UNITED STATES PATENT AND TRADEMARK OFFICE

09/921,844

Gary K. Michelson

Office Action Summary	Application No. 09/921,844	Applicant(s) MICHELSON, GARY K.	
	Examiner Bruce E. Snow	Art Unit 3738

Referring to figure 6, **Abei et al** teaches a teaches a spinal implant comprising a plurality of pyramid-shaped projections 28 formed on the upper and lower surfaces of the implant which are slanted to *"allow for ease of insertion and avoid retroplusion after insertion (4:30 et seq.)"*

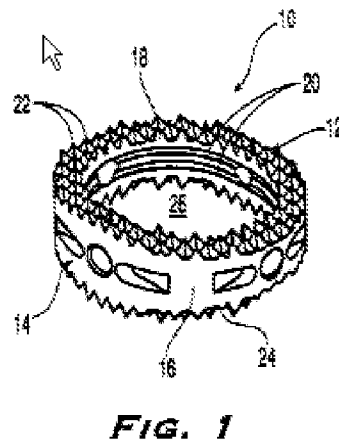
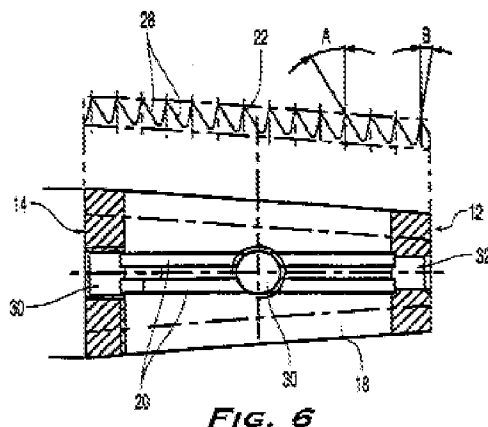
The projections are slanted towards the trailing end 14, therefore, having a forward facing facet which is longer than a rearward facet. The projections further include side facets and a rectangular base. However, Abei et al is silent regarding the length of the forward facing facet having a maximum length as measured along a line parallel to the maximum length of the base, the maximum length of the forward facet greater than the maximum length of the base.

Referring to figure 1C, Fraser teaches a similar spinal implant having surface projections 18 wherein the rearward facet 34 can either have a positive slope or negative slope.

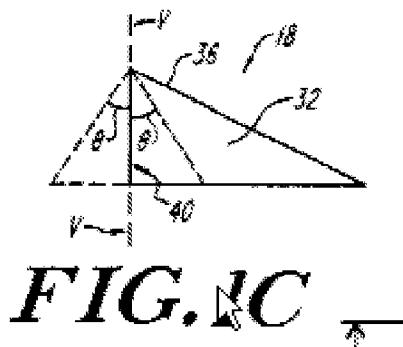
It would have been obvious to one having ordinary skill in the art to have formed the rearward facet of Abei et al forming a negative slope such that the length of the forward facing facet is greater than the maximum length of the base such that the projections dig into the bone and better resist expulsion. Therefore, the maximum length of the forward facet is greater than the maximum length of the base (claim 219).

Paul et al also teaches a spinal implant having projections with four facets as shown in figures 9, 10A, and 11.

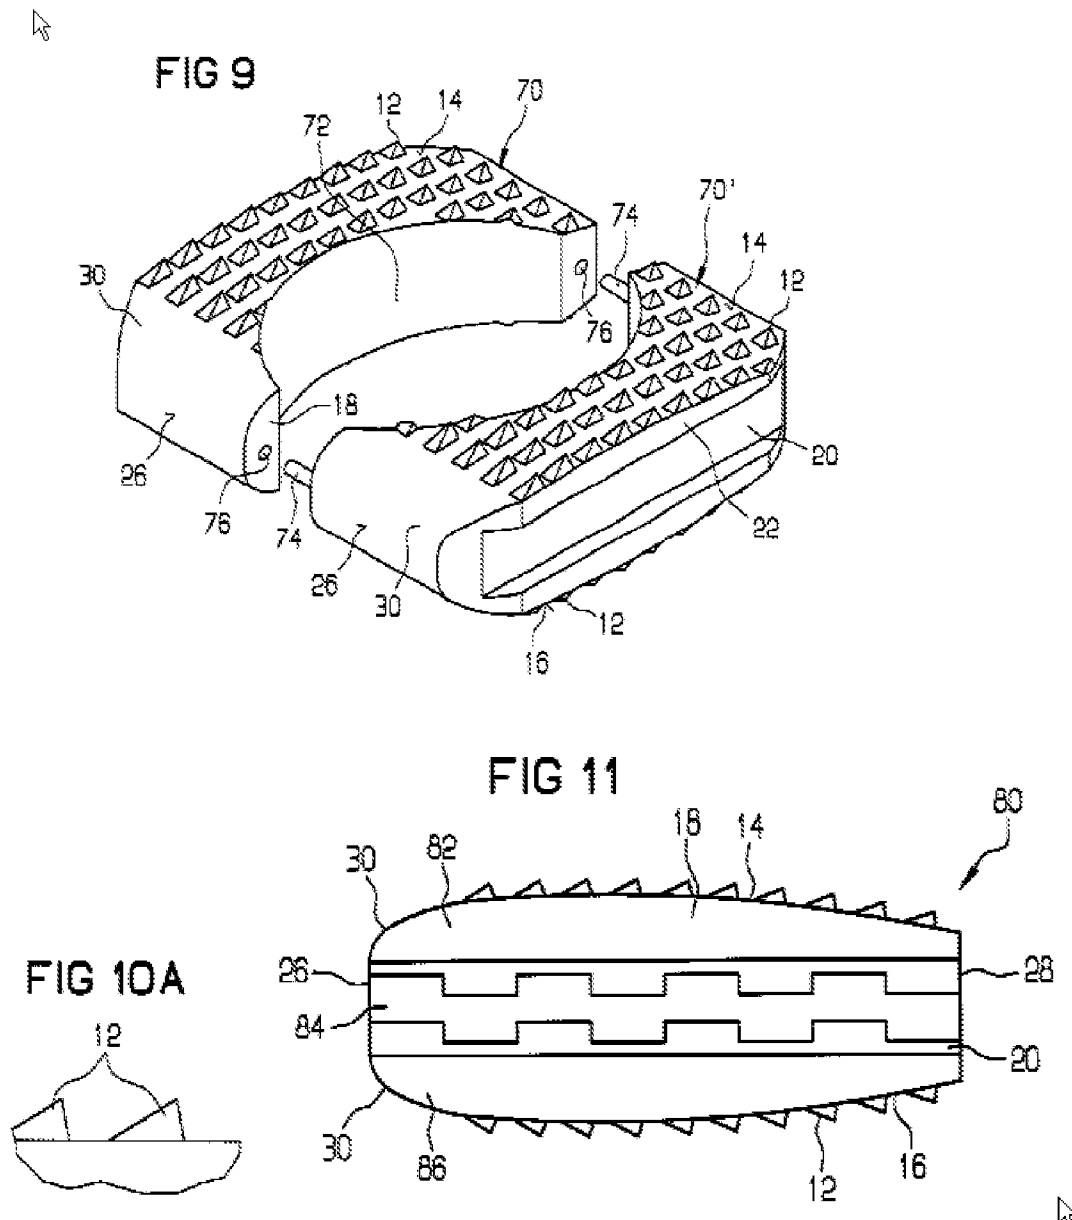
It would have been obvious that one skilled in the art would have appreciated that the “other shapes” and “overall geometry of the fins” would include four faceted projections as taught by Paul et al with predictable results. This would have produced the projection as claimed in applicant's claim 219 wherein the length of the forward facing facet having a maximum length as measured along a line parallel to the
